318 SOUTH TCE, ADELAIDE

020/A054/14 V5

Application No	020/A054/14 V5
Unique ID/KNET ID	2019/13724/01
Applicant	BCH Services
Proposal	Variation to DA 020/A054/14 (and variations V1, V3 and V4) that seek construction of two exhaust flumes to the front of the property, alteration to the rear windows/doors, verandah form and link associated with Davaar House, altered front fence and position, use of Colorbond for roof cladding, various internal alterations, change in levels across the site resulting from car park location/levels above ground and associated hard and soft landscaping and paving (part retrospective).
Subject Land	318 South Terrace, Adelaide
Zone/Policy Area	City Living Zone / Policy Area 31
Relevant Authority	SCAP
Lodgement Date	10 October 2019
Council	Adelaide City Council, Development Plan Consolidated 25 July 2019
Type of Development	Merit
Public Notification	Category 1
Representations	Not Applicable
Referral Agencies	<u>Mandatory (Schedule 8):</u> Nil <u>Non-Mandatory:</u> City of Adelaide Government Architect

Report Author	Janaki Benson
RECOMMENDATION	Development Plan Consent be GRANTED

Figure 9 – Proposed Fencing

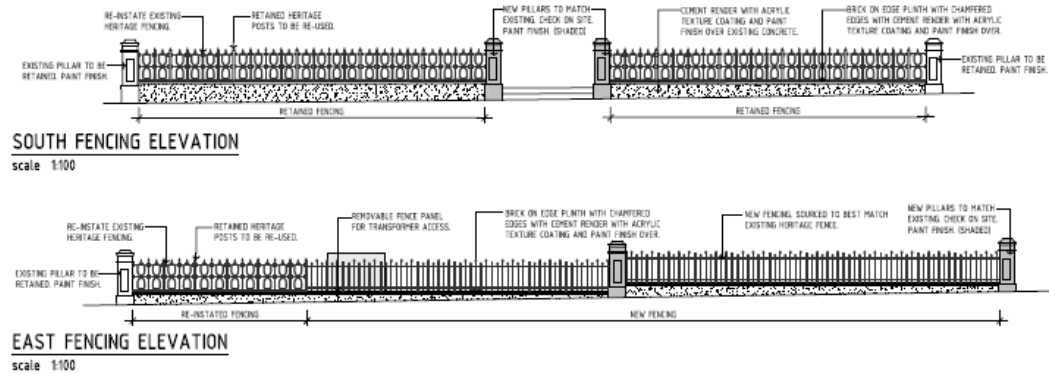
The GA and the City of Adelaide Council reviewed the original fence design proposed as part of variation 5 this application (above) and sought clarification regarding fence details, encroachment (of handrails on to Council land) and the proposed design approach – these comments can be viewed above under 4. *INFORMAL REFERRAL BODY COMMENTS*.

Figure 10 – Amended Fencing Design

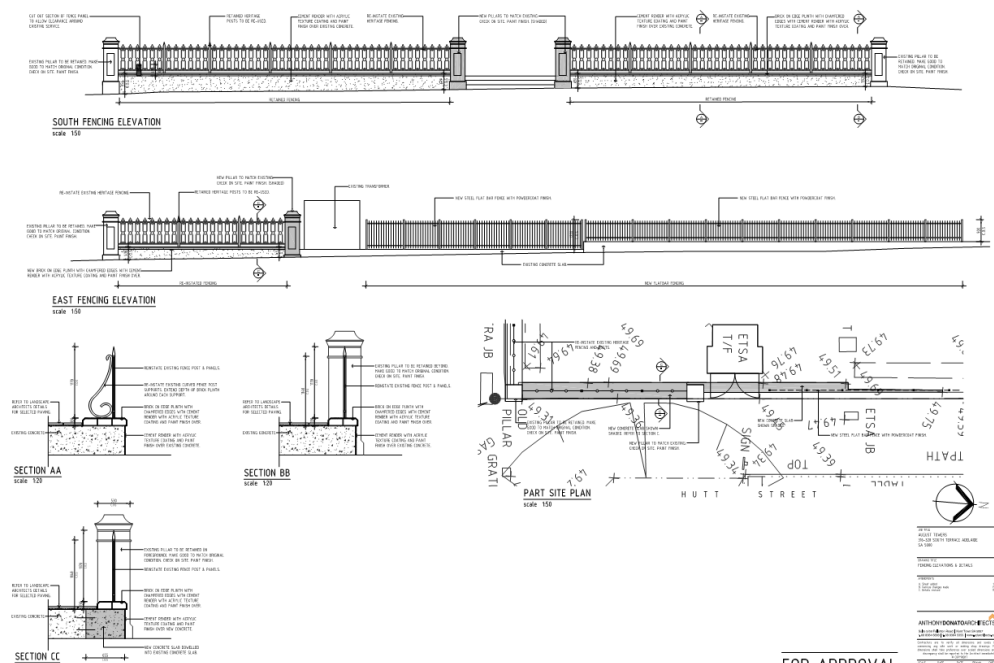
Council considers that the setting of Davaar House and the heritage listed cast iron fence will be compromised due to the raised slab level. However, the approach to the fence as outlined in the HIS is supported and outlines the rendering of the concrete slab at street level will marginally raise the plinth level and overall height of the reconstructed fences. The profile and detailing of the surviving masonry pillars will also be accommodated, allowing for the finished appearance to closely resemble the former historic fence form. As previously approved, at the ends and openings in the reconstructed fence sections, matching masonry pillars will be erected.

The contemporary approach for the new section of fencing along Hutt Street is supported also by the HIS, and the GA - in terms of providing an aesthetic to complement the urban plaza approach to landscaping. The GA however has recommend that the new section of flat bar fencing extend in front of the ETSA transformer with a removable panel (as previously proposed) to achieve a consistent presentation to Hutt Street. A reserved matter will seek this detail in the event of SCAP support.

- The height to the flat bar fencing will match the top rail of the cast iron fence and the steel pickets will match the height of the cast iron spears, as desired by Council.
- The front fence will utilise the existing panels and will reflect the character and appearance / design of the original fence.
- The colour of the fence will be black.
- Beyond the reduced length of historic fencing along Hutt Street, a simply detailed, contemporary steel palisade fence is proposed, of matching height to the adjacent cast iron fence panels.
- The handrail (adjacent the stairs) will be constructed to ensure there is no encroachment into the Council land.

Figure 12 – Link, Approved Vs Proposed

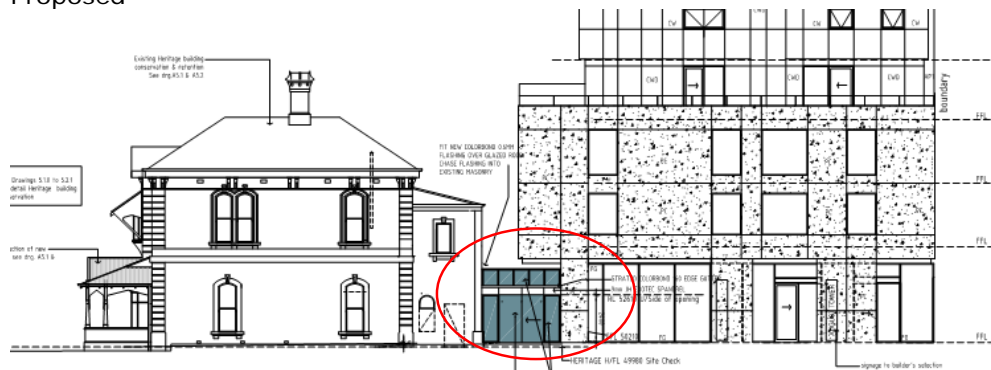
The external changes to Davaar House seek window/door modification to the rear, replacement roof cladding (Colorbond Grey, previously Galvanised Iron) and design changes to the approved glass link between Davaar House and the tower to accommodate the as-built levels.

Figure 16 - Proposed Landscaping with Exhaust Flumes (Revision F) and Associated Render (original plan for V5)

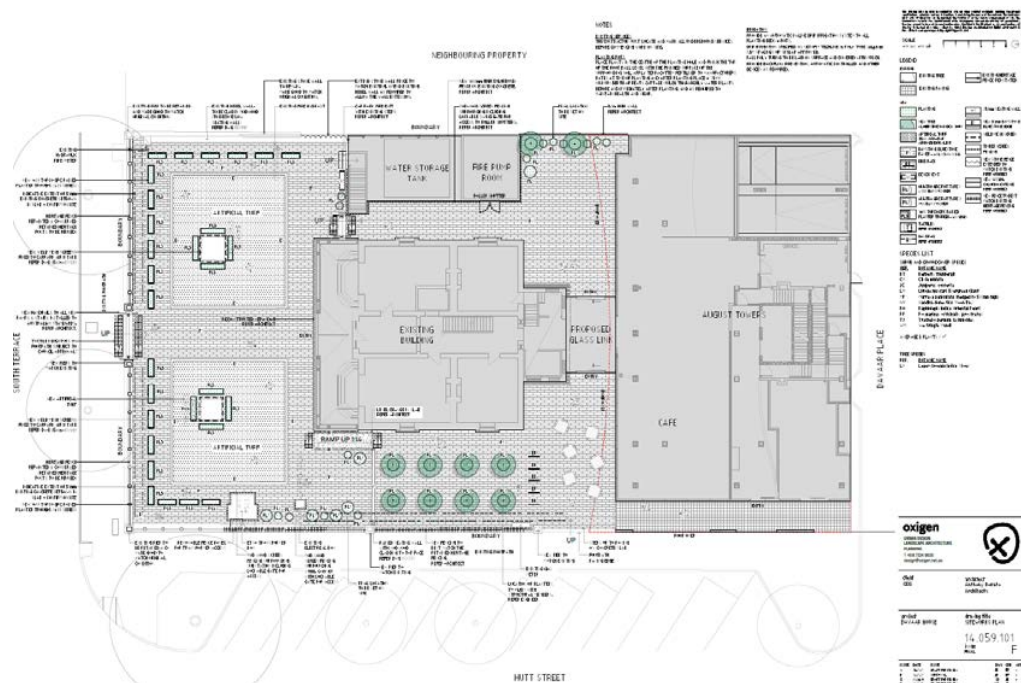
The amended landscaping design above in Figure 16 (and render) sought one type of bluestone paving, regularly spaced 1.6 metre long proprietary GRC planter troughs along the west, south and east frontages, a series of 1.2 metre diameter and 0.9 diameter GRC round pots along the east and west boundaries and eight regularly spaced trees in round GRC planters in the location of the communal open space. Fronting South Terrace, two symmetrical squares edged with artificial turf where proposed. Climbing plants on a weld mesh enclosure were also proposed to screen the two large exhaust vents located within the artificial turf area. Review of the 'traditional' landscape design and use of artificial turf (from a durability and environmental perspective) approach proposed was recommended by the GA, with consideration given to a high quality contemporary urban plaza treatment suggested, rather than a repetitive formal design and use of artificial materials.

The landscaping approach has since been amended by in line with this recommendation and shown below in Figure 17. Amended renders were also requested from the applicant to demonstrate the new landscape approach, however these were not available at the time of writing this report but are anticipated to be furnished at the SCAP meeting for member's consideration.

Figure 17 - Proposed Landscaping and Exhaust Flumes (Revision H)

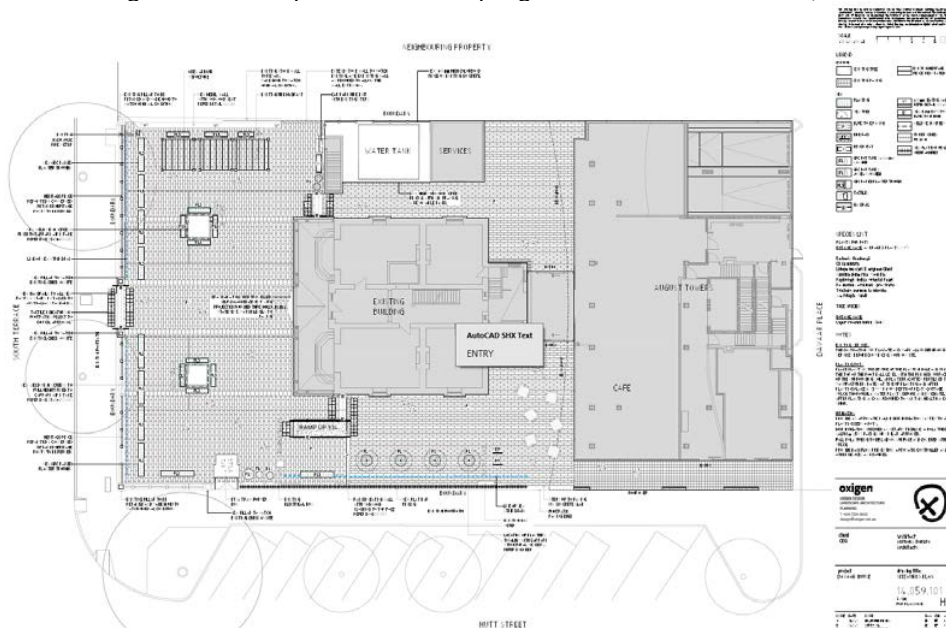
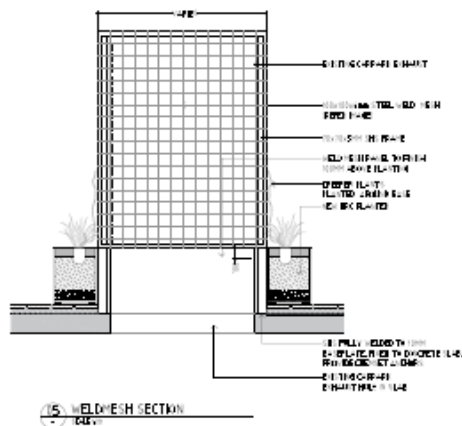
The latest landscape design (Figure 17) still seeks to screen the two, 2.3m high exhaust flumes as originally proposed (noting it has not been confirmed that the venting will not impact on creeping foliage) however a variety of blue/gray paving sizes and patterns are proposed, along with wooden seats and GRC planting troughs at the site. A mix of plant species are proposed for the troughs and the majority of species proposed are intended to be evergreen with one deciduous species (berberis) intended to add colour and seasonality. The latest landscape design does not seek to screen the relocated padmount transformer and adjacent electrical services box at the eastern front of the house, based on the updated advice in the HIS. The visible wall of the fire escape enclosure on the western side of Davaar is intended to be left plain (rather than screened) but painted mid-dark stone colour to reduce the visibility from South Terrace/Hutt Street corner. An arbour structure is also proposed adjacent to the western boundary in front of this enclosure, reducing its visibility (albeit no elevations have been provided at this stage) adjacent the western boundary to provide shade in summer and allow a wisteria vine to grow over.

The HIS considers that the simplified contemporary landscaping sought will provide a suitable setting for 'Davaar', with *'..little visual impact at the South Terrace/Hutt Street corner.'* The landscaping design is also considered acceptable by Council and the approach for a paved urban plaza treatment is supported by the GA in principle (in lieu of artificial turf as previously proposed). The inclusion of the arbour element on the western side of Davaar House is supported by the GA, as it assists in screening the services/basement stair enclosure and contributes to the amenity of the plaza. The GA however has noted the following concerns with the current design:

- *The number of above ground planters further reduced (from the originally submitted revision F plan). This includes:*
 - *Removal of the round planters on the western boundary between the fire pump room and August Towers building;*

- *Reduction in the number/extent of planters on the eastern boundary between the south east corner and the ETSA box (a single rectangular planter is proposed, in lieu of three smaller planters);*

- *A single rectangular planter is proposed on the eastern boundary between the electrical box and raised seating wall in lieu of a group of five round planters;*

- *Reduction in the number of planters/trees on the eastern boundary between the fence and Davaar House (a single row of round planters/trees is proposed, in lieu of a double row).*

- *The linear paving detail aligning with the external walls of Davaar House intersect the exhaust vents at different locations and have the potential to highlight the inconsistent set out and size of the vents. Further review of the hardscape design is recommended cognisant of the inconsistent as-built conditions.*

- 1.1 A landscape plan demonstrating:
 - the concealment of the required irrigation infrastructure;
 - additional greening elements within the limits of the basement structure to mitigate the visual and environmental impacts of the large expanses of paving;

- evidence that the venting will not impact on creeping foliage adjacent the exhaust vents;
 - provision of appropriate bike parking spaces; and
 - paving treatment that provides a variety in texture, colour and materiality and response to the as-built conditions.

FIGURE 26(A) STAIRWAY LOCATION AND HANDRAIL EXTENSIONS AT BOUNDARY

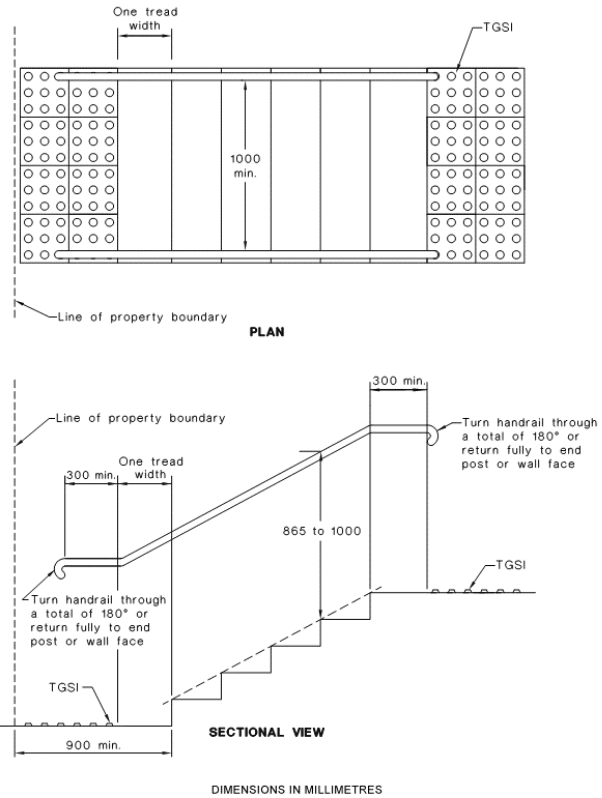
It is noted that the handrails to the front entrance stairs encroach over the front boundary.

AS 1428.1 requires that when stairs are to be located adjacent a property boundary, the stair shall be set back a minimum of 900mm from the boundary line (refer to excerpts from AS 1428.1 below). This is to mitigate any hazards within the public realm.
